NO: VS-052
DATE: May 2015

PRODUCT: 3Z4S-LE VS-1614H1 Lens
TYPE: Discontinuation Notice

3Z4S-LE VS-1614H1 C-Mount Lens Discontinued

Dimensions

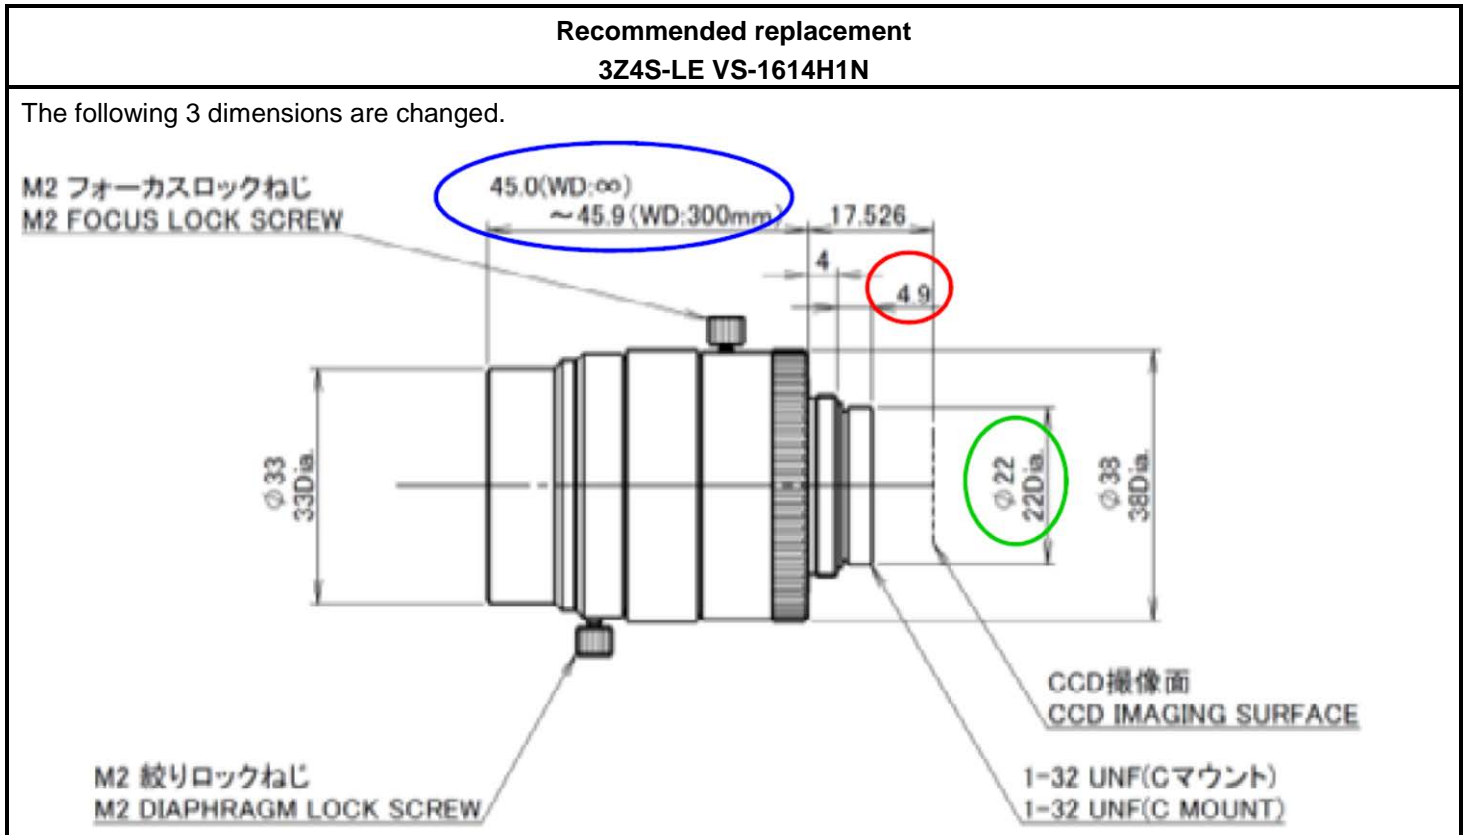
There are slight differences in the dimensions, characteristics, and operation ratings that will affect the image data collected by the vision sensor camera. Have the user confirm that the changes do not influence setting of the vision sensor.
